14MP
14 Milton Place
Gravesend
DA12 2BT
Kent

Interior refurbishment
Listed Building Consent 20250269

Details showing how the insulation boards will be installed in relation to the skirting boards and architraves.
Sash windows with architrave:
-Bedroom 1, 2, 3, 4
-Kitchen
-Reception room

14MP11/PR Rev.2

Detail D
Sc.1:2.

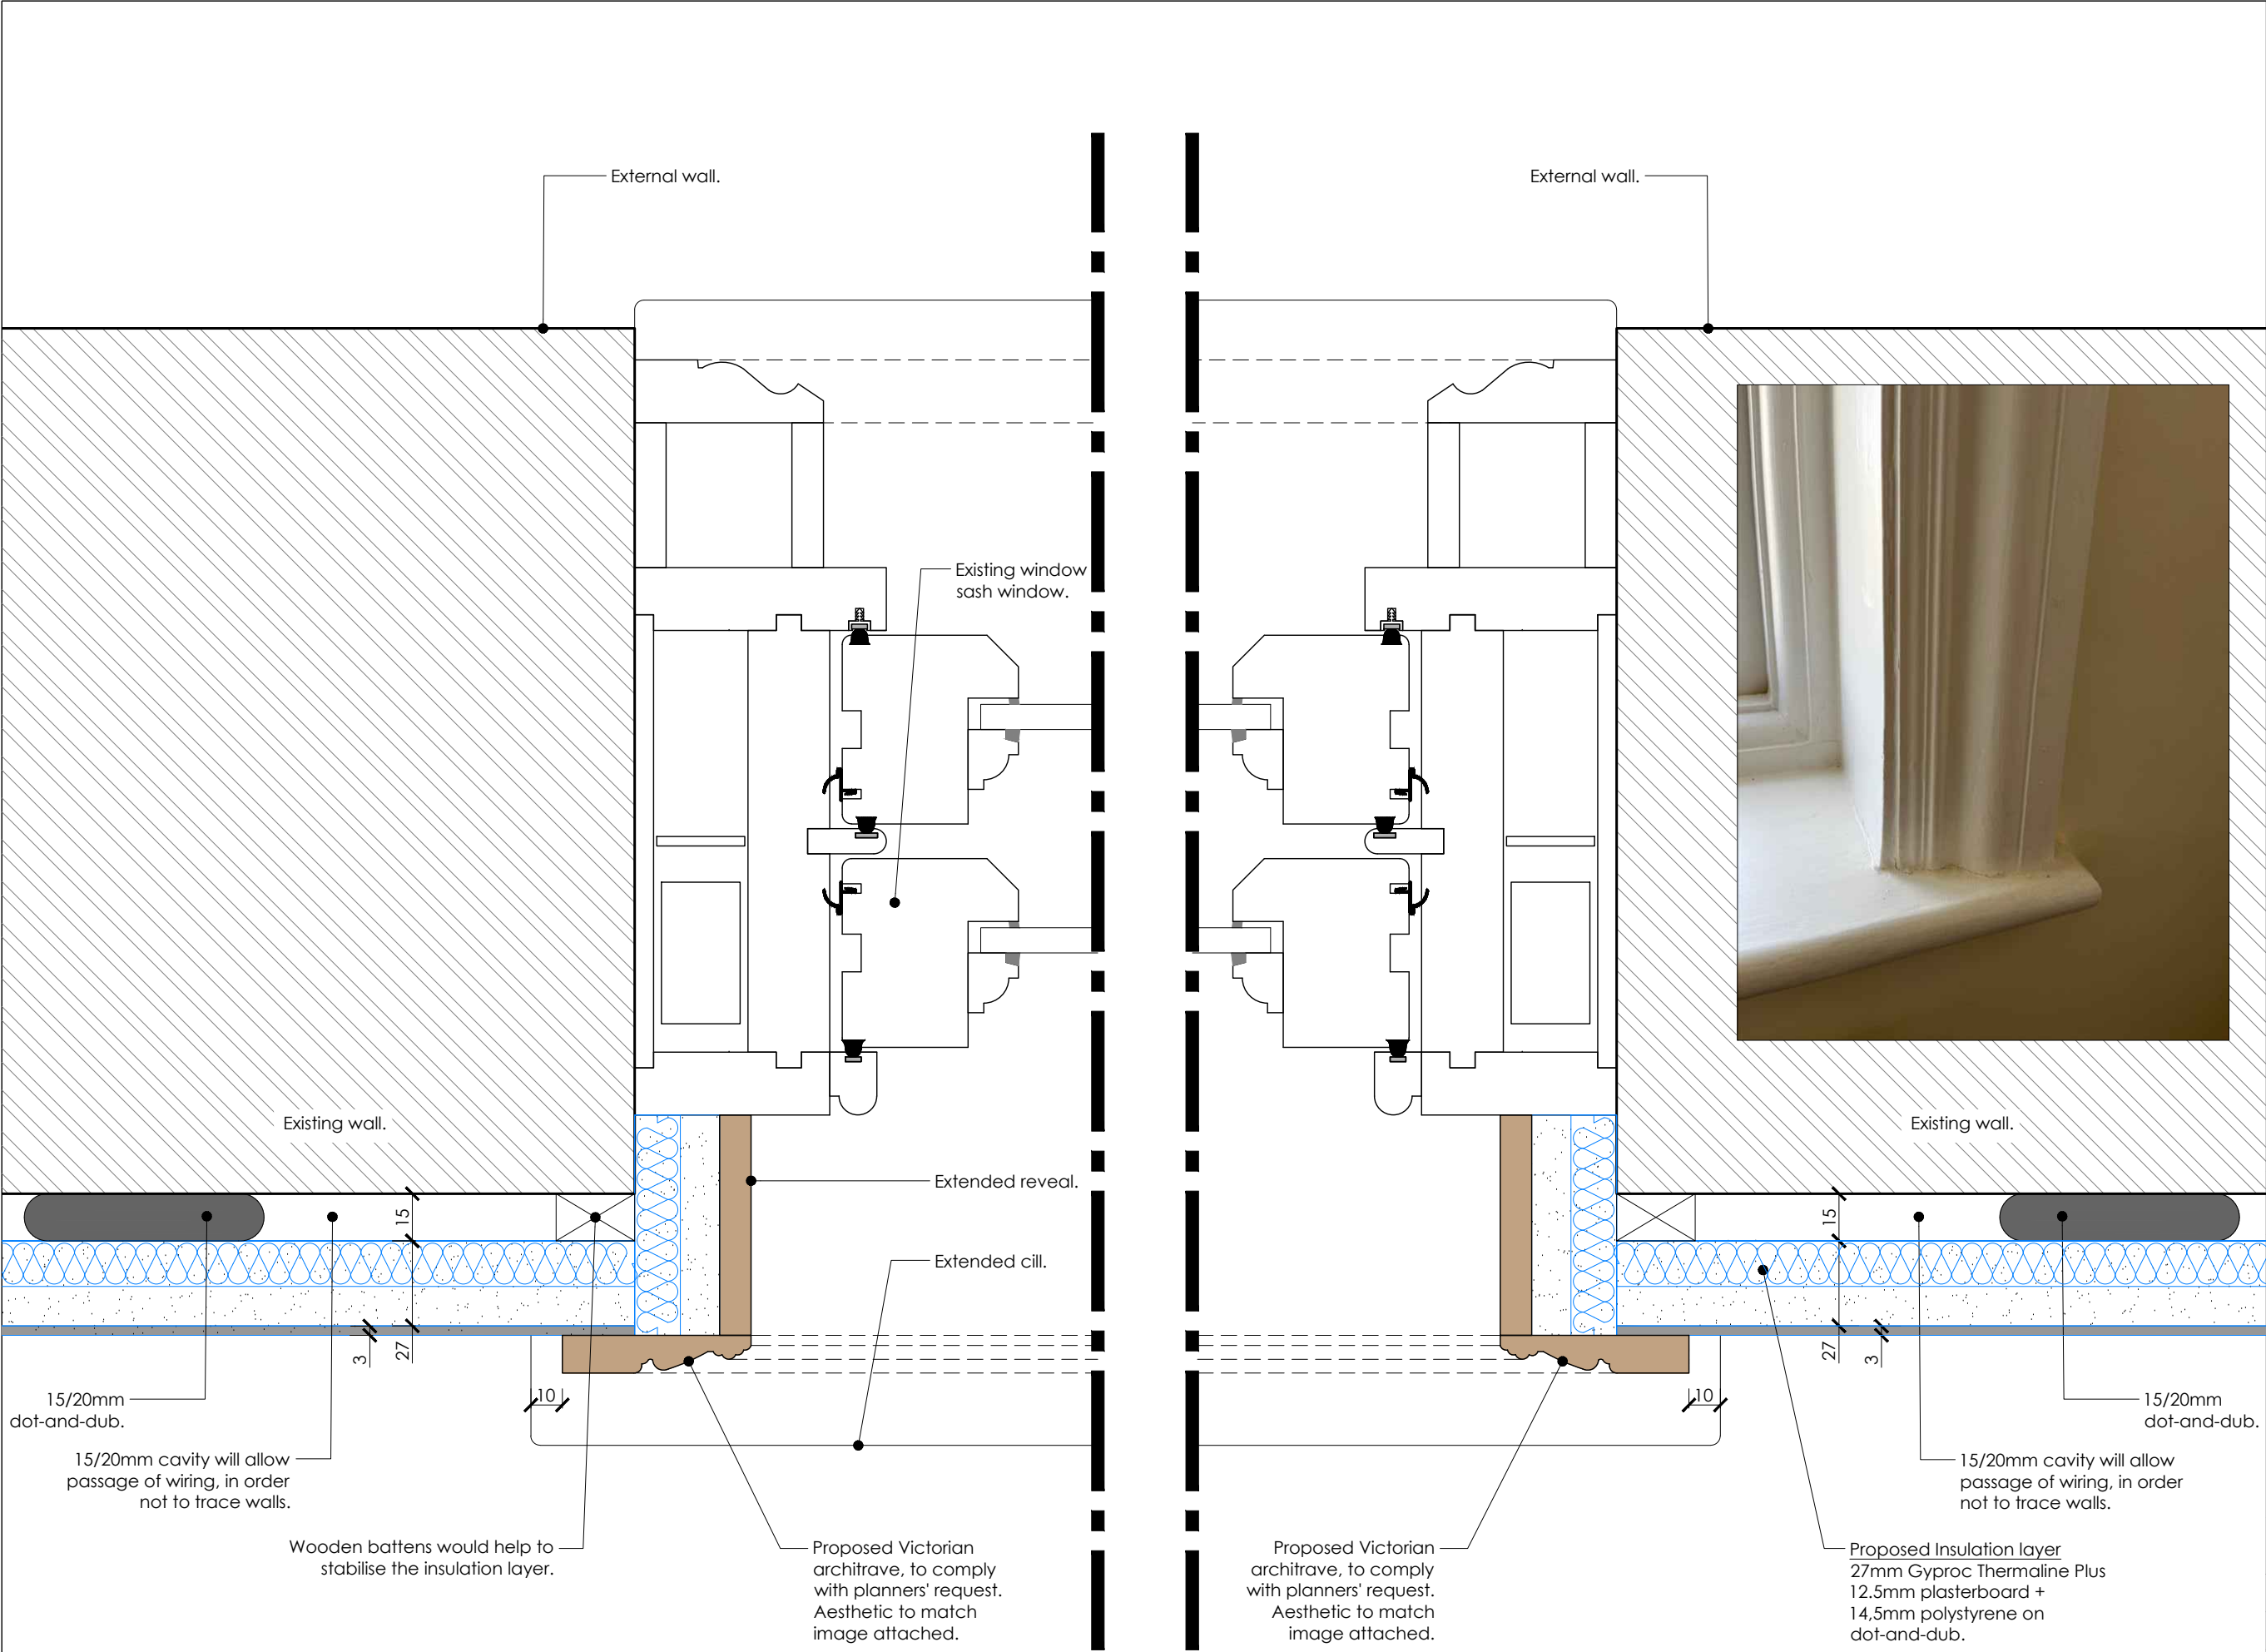
- 10/07/2025 - Rev.1
- Window's reveals adjusted by extending the window cill and reveal board with an Victorian architrave.
 - Proposed new Victorian skirting board , as per planners' suggestion.

- 23/07/2025 - Rev.2
- Windows architraves' setting amended as per planners' request.
- Architrave to be added also to Bedroom 2, 4 and Reception room.
